# **AAV IRAM TRANSMISSION REVIEW**

## **INTERIM REPORT TFLRF No. 334**

Contract No. DAAK70-92-C-0059

**Figure 1. Insufficient Gasket Area**

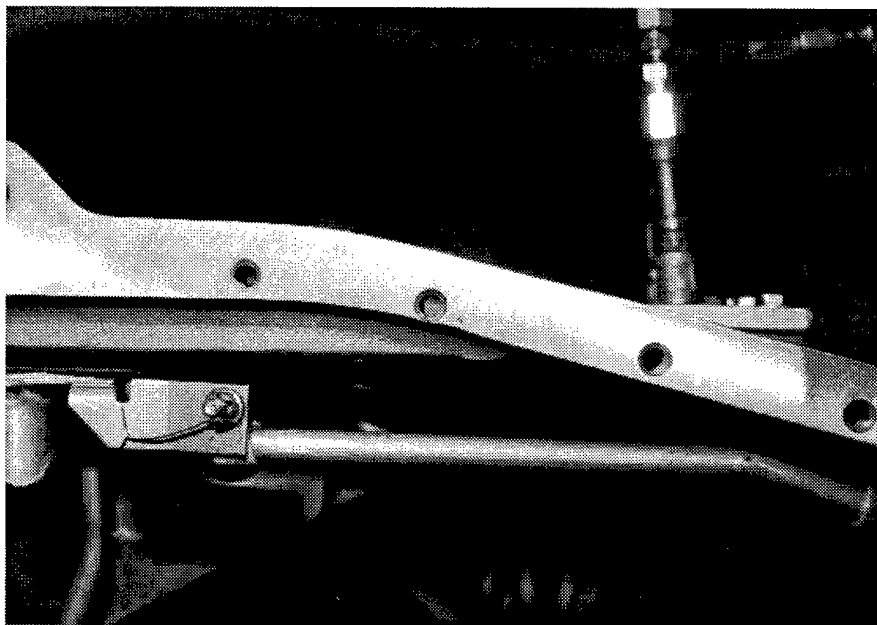
The gasket leakage stems from the insufficient gasket area (Figure 1), housing warpage (Figure 2), and poor quality gasket material. The access plate on the rear of the transmission, a common leakage area, has a cutout that leaves a very thin gasket surface, plus a very sparse bolt pattern in the same area. Attempts to torque the plate bolts to increase the pressure on the gasket tend to buckle the plate corner effectively reducing the pressure on the gasket. Additionally, a matched end plate and speed change housing may have had the bolt pattern shifted during original production such that insufficient gasket sealing surface remains. Gasket leakage also occurs due to warpage of the speed change housings. The warpage stems from the welding procedures used to repair the cracks in the housings (Figure 3).

**Figure 3. Crack at Dowel Pin Boss**

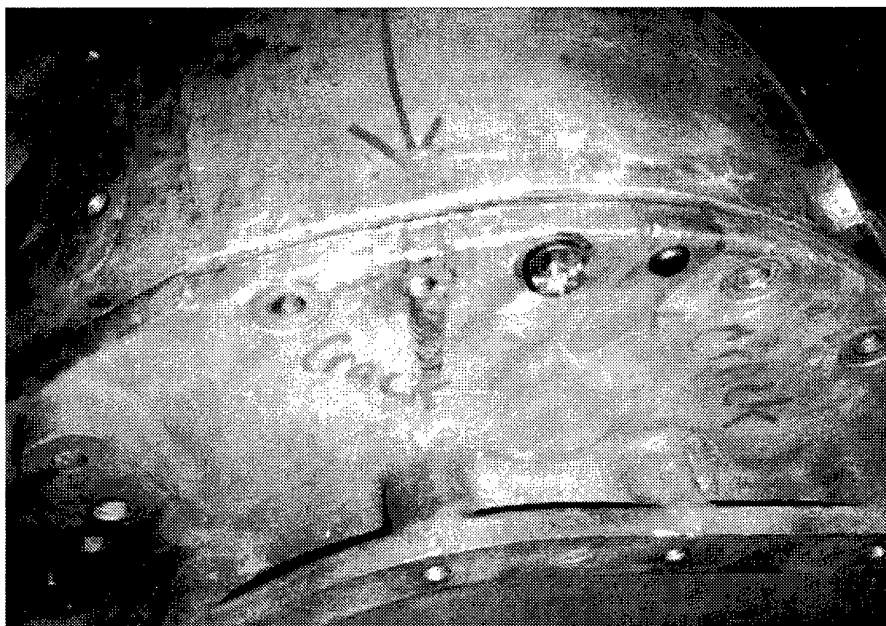
Housing cracks appear due to disassembly and handling procedures and incorrect vehicle operation (Figure 3). Each time a transmission is rebuilt increases the likelihood of speed change housing damage. An example is that a crack typically shows up at a location consistent with the lower jackscrew used to separate the end plate from the speed change housing. It was noticed that there was localized yielding of the aluminum housing material at all jackscrew locations. Cracks were evident at the lower speed change housing dowel pin boss (Figure 3). The cracks in the dowel pin boss are typically repaired with Devcon epoxy putty. Another typical speed change housing crack occurs due to failure of the fan drive universal joint. The fan drive universal joint fails, and the flailing drive shaft impacts the speed change housing causing cracks. An ECP was developed to prevent this damage but was never implemented.

**Figure 4. Improved Filtration System**

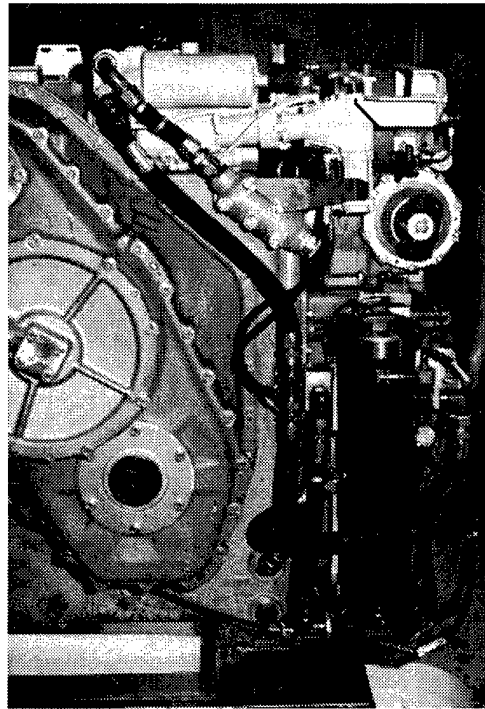
The IRAM transmission has incorporated a new Parker filtration system, which improved the efficiency and load capacity of the older filtration system (Figure 4). The drawing for this system is shown in Figure 5. This filtration system efficiency is rated as being 50% efficient at 2  $\mu\text{m}$ ; 95 % efficient at 8  $\mu\text{m}$ ; and 98.7% efficient at 10  $\mu\text{m}$ . The apparent capacity for the Parker system is 200 grams. Based on past experience on other equipment with similar clearance (2), the critical particle size, which can cause significant damage, is approximately 6  $\mu\text{m}$ . Although the

Parker system has improved the filtration performance, for the ultimate practical protection, a 5  $\mu\text{m}$  filtration system should be investigated.

Figure 5. Barstow Recommended Oil Flow Modification

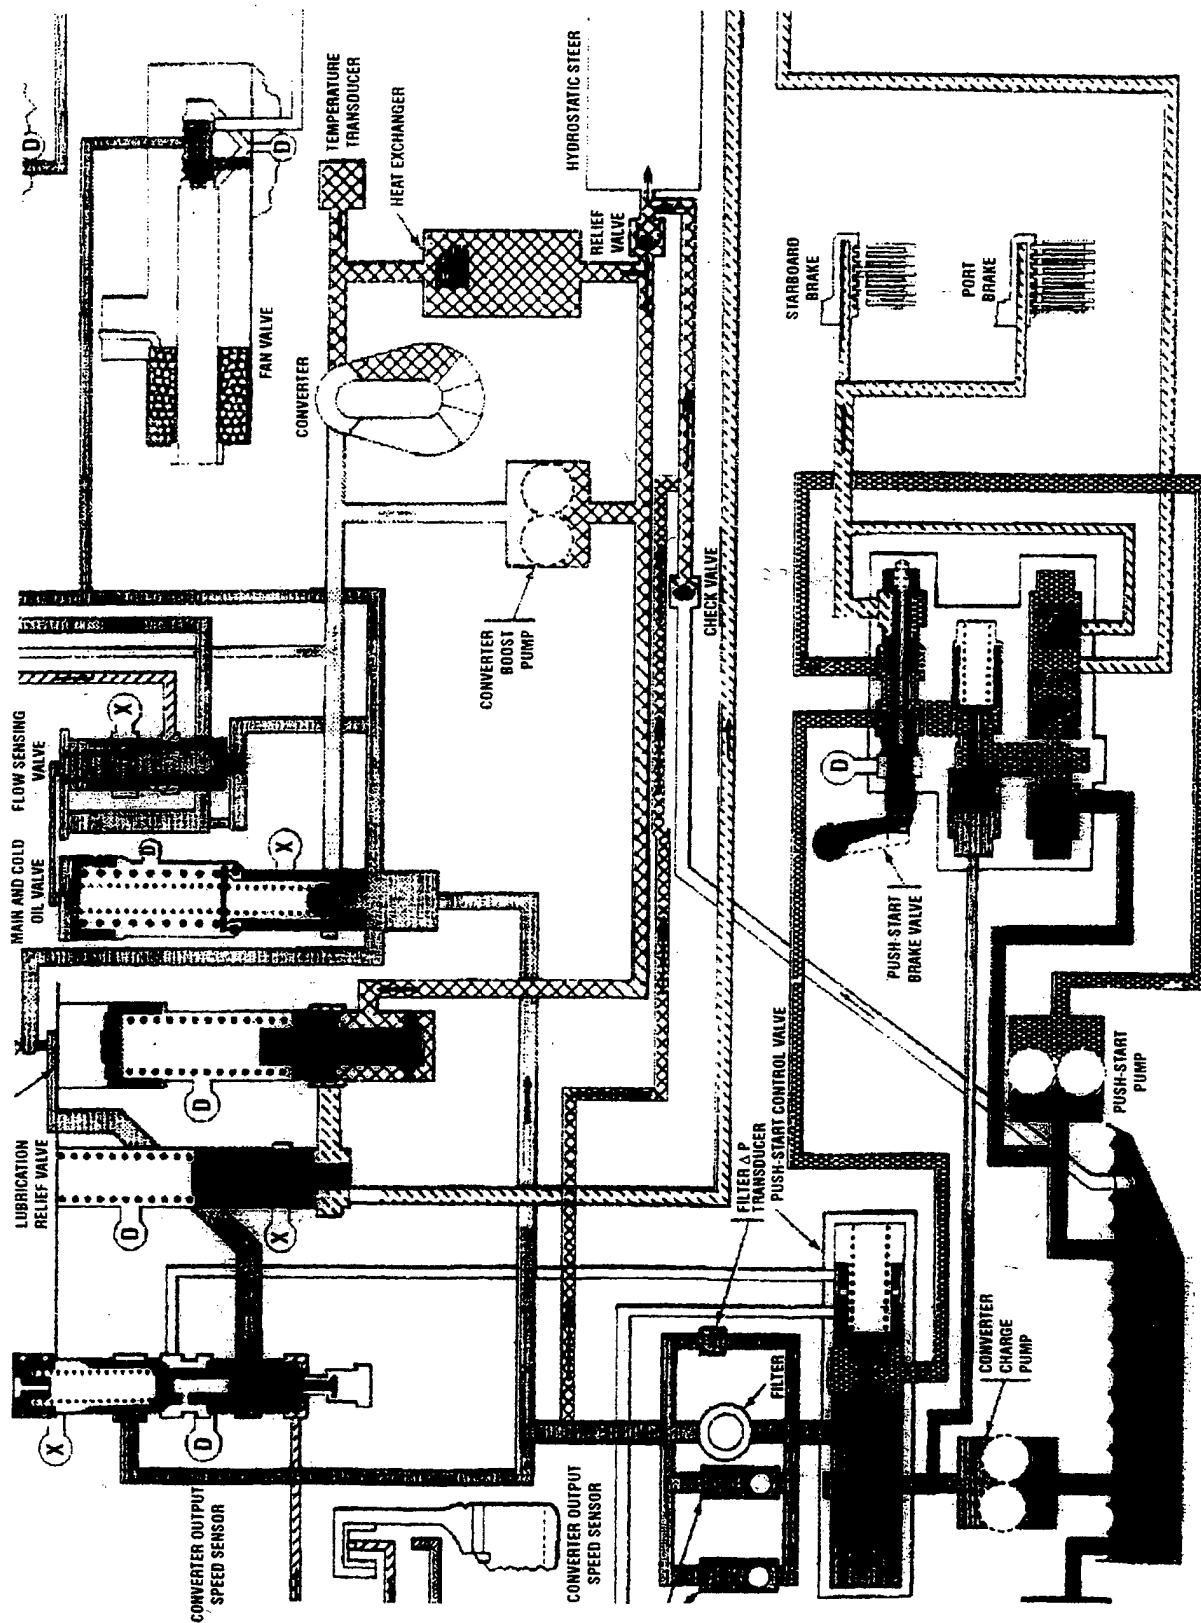
MC3 submitted a suggestion for improving the quality of the oil entering the HSU by modifying the filtration system. The re-plumbing of the oil system would tap into the oil line after the main oil filter (Figure 5). This method would improve the quality of the oil entering the torque converter pump, bypassing other debris-generating components. If approved, modification needs to be evaluated to determine if the oil flow pattern change and pressures effect the operational performance, i.e., AVTB.

**Figure 8. Flange Deformation Due to Jackscrews**

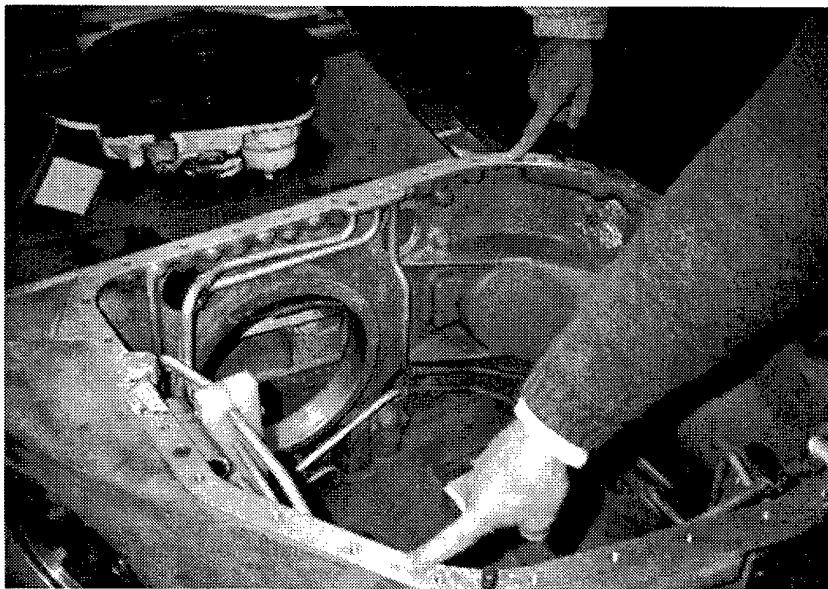
Speed change housing problems included housing cracks from jackscrews (Figure 8), fan drive universal joint failures, tubing swages, mismatched nylon tube locating blocks, bearing bore damage from spun bearings, and housing warpage from crack welding procedures.

**Figure 9. Bearing Bore Damage**

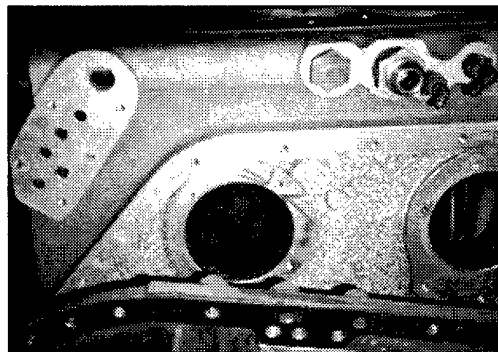
Inspection of several speed change housings indicated the bearings for the clutch shafts have been spinning within the bearing bores. The bearing press-fit is obtained by heating the aluminum housings to 300°F and cooling the steel bearing to -38°F. AERA, Inc. analysis suggests when the housing and bearings reach room temperature; the stress in the housing bores exceeds the yield strength of the material, relieving some of the press-fit (Figure 9). When the transmission reaches its operating temperature in the 190-210°F range, the greater thermal expansion of the housing relieves the press-fit and allows the bearings to spin. Housing bearing bores, which reveal extensive damage from spun bearings, are sleeved with a material of higher yield strength.

**Figure 10. New Twin Disc Seal Ring**

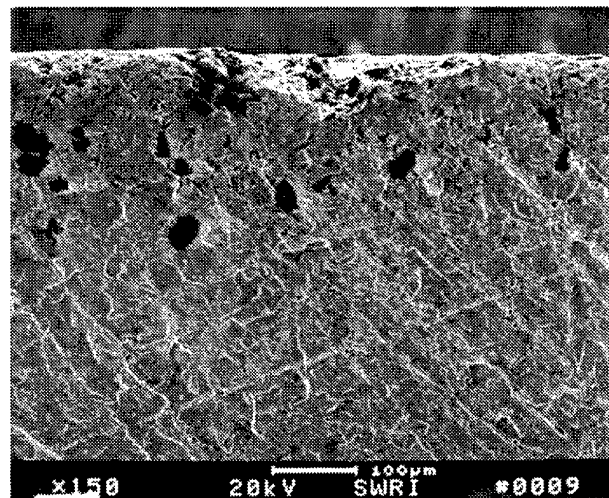
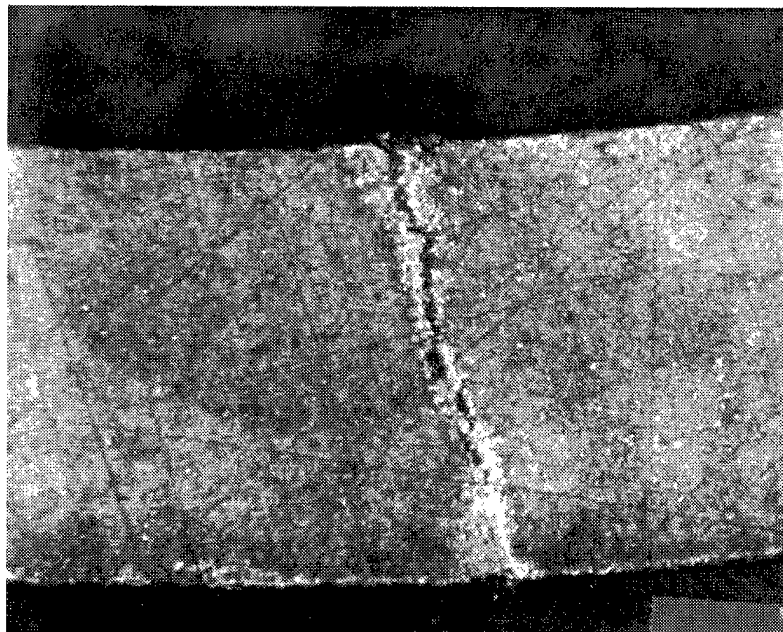
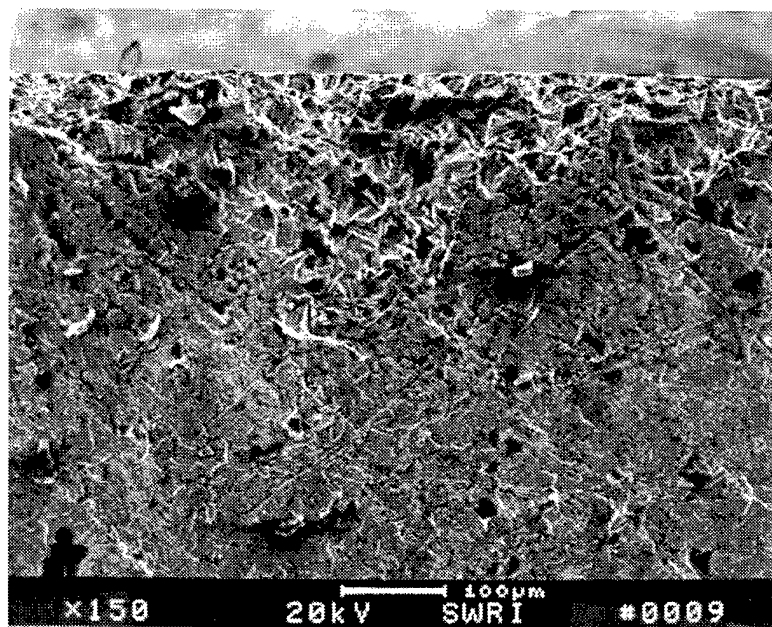
Following the hardness tests, the seal rings were examined under a low power stereomicroscope and in a Scanning Electron Microscope (SEM). The new Twin Disc seal ring exhibited chipping along the machined edges (Figure 10). A large radial crack was also present in the new ring (Figure 11). The broken Twin Disc seal rings (Figure 12), removed from the transmissions at MCAGCC exhibited more extensive chipping than the new seal ring.

**Figure 13. New Aceomatic Seal Ring**

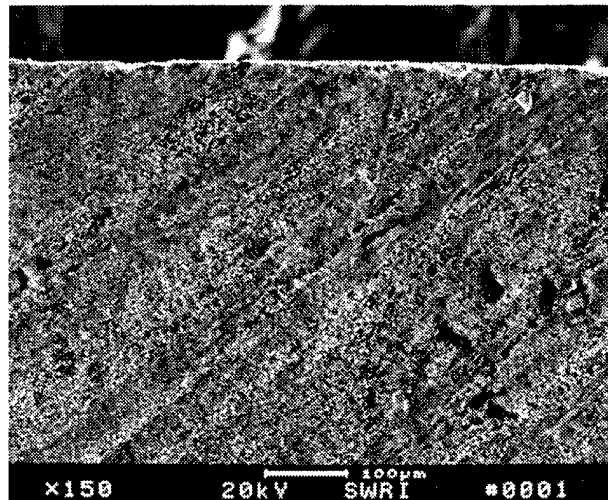
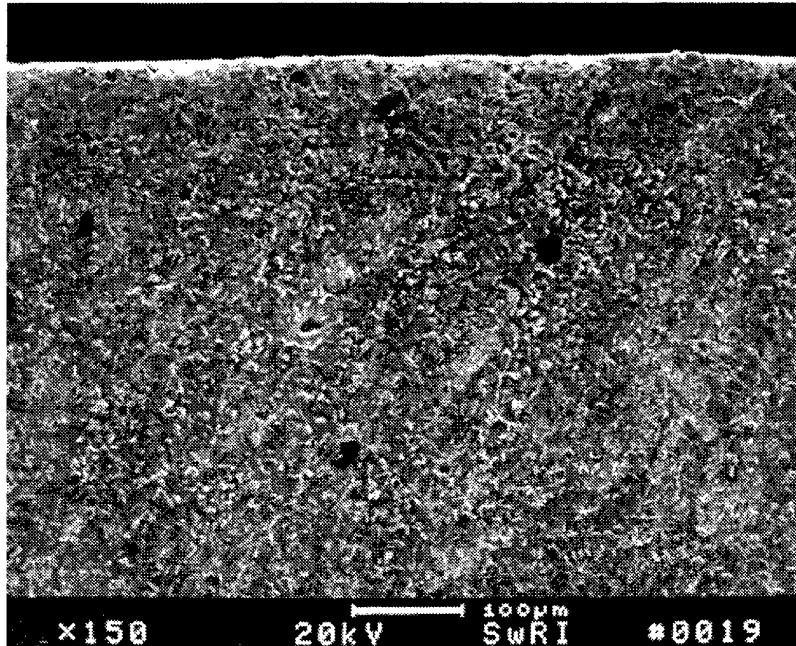
The appearance of the new Aceomatic seal ring was very different from that of the new Twin Disc seal ring. Very smooth edges, as shown in Figure 13, were evident around the entire ring, and no evidence of chipping or cracking was observed. The used Aceomatic seal rings that were delivered to SwRI from Barstow also exhibited smooth edges that were free of chipping and cracking, Figure 14.

**Figure 17. Tube Swage Problem Areas**

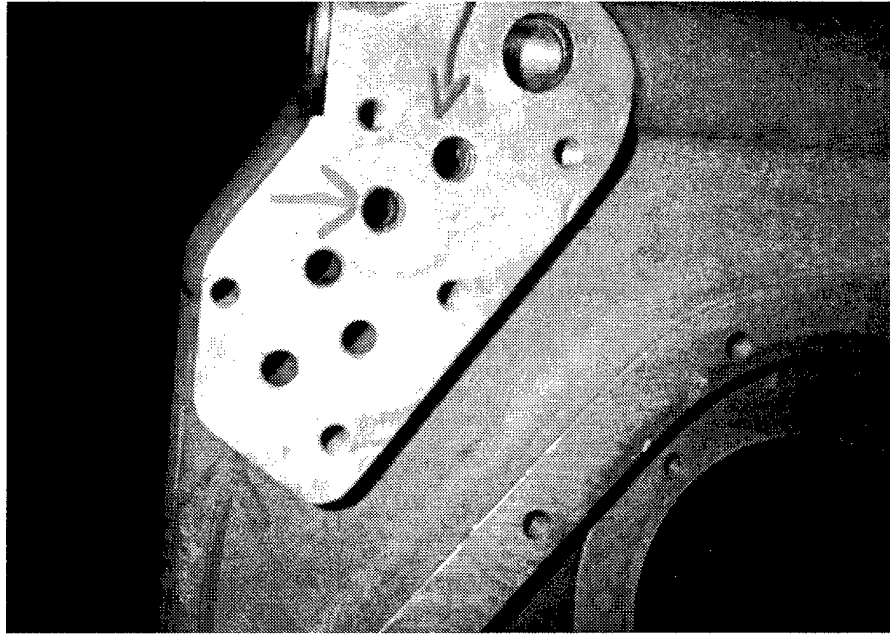
The problem is once the tubes are swaged into their respective holes (Figure 17); vibration of the material loosens the fit. In addition, if the tube swaging process is not performed correctly, the tubing wall thickness becomes very thin, cracking as a result of fatigue. Both of these problems result in the loss of oil pressure.

The proposed method for the tube swaging is to set a limit on the hole diameters, then swage the tube until the ID of the tube is within a prescribed limit. The procedure will result in a 5% to 15% swage of the tube. The advantages of this method are that the number of measurements is reduced and no calculations are required. It will also be easy to determine in a post inspection if the tubes were properly swaged simply by measuring the ID of the installed tubes. The ability to check the degree of swage of an installed tube will be very helpful toward eliminating the improperly installed swage tubes. Although this procedure should aid in reducing the number of tubing swage problems, it is felt that this problem needs additional investigation to produce a better solution.
